PUBLIC INTEREST REVIEW FOR GROUNDWATER APPLICATIONS

SUBJECT: Application G- 18169 Supersedes review of NA  
Date of Review(s)

**A. GENERAL INFORMATION:** Applicant's Name: Duane Grant, Pueblo Mountain Land Co. LLC  
 County: Harney

A1. Applicant(s) seek(s) 7.2 cfs from 4 well(s) in the Malheur Lake Basin,  
Alvord Lake subbasin

### Water-Level Trends in Nearby Wells

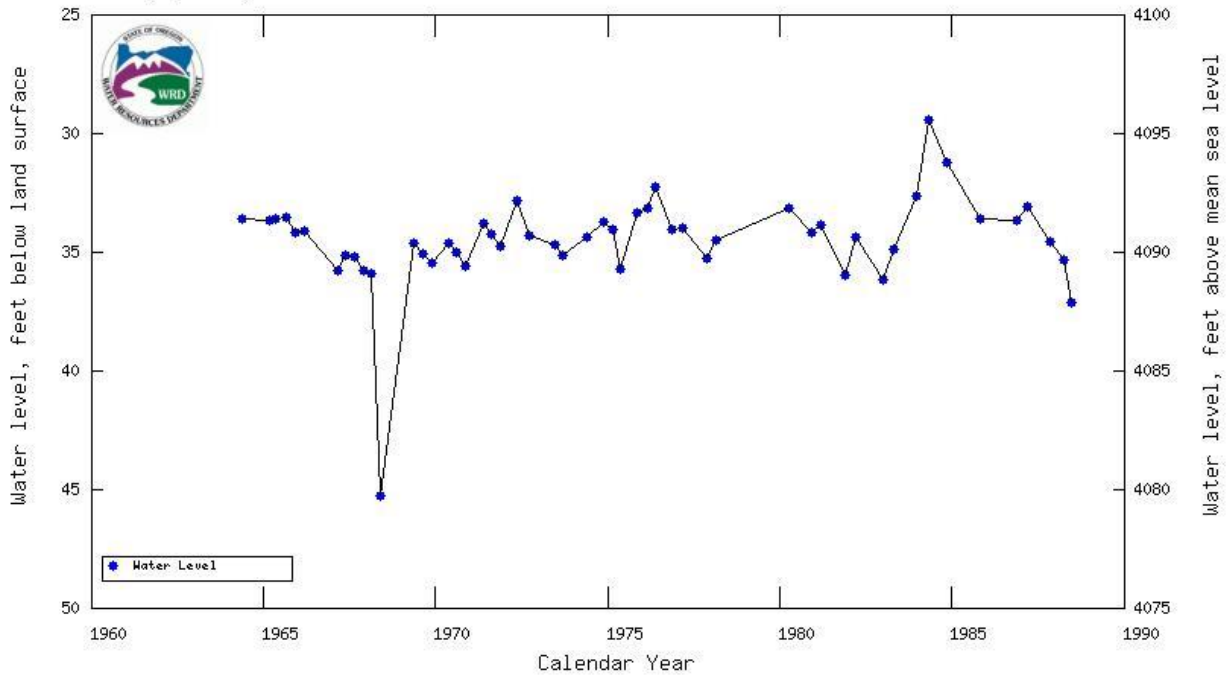
State Observation Well 198 (HARN 1806) is located over ~5 miles to the southeast of the proposed wells, and records a ~0.5 ft/year or less water level decline since the 1980s. Existing well HARN 1793 is non-current State Observation Well 197, and has a fairly consistent water level record from the mid-1960s through the late 1980s. Based on the 11/11/2015 static water level reported on this application HARN 1793 has experienced a ~12 foot decline since 11/1987 – or about ~0.4 ft/year over this period.
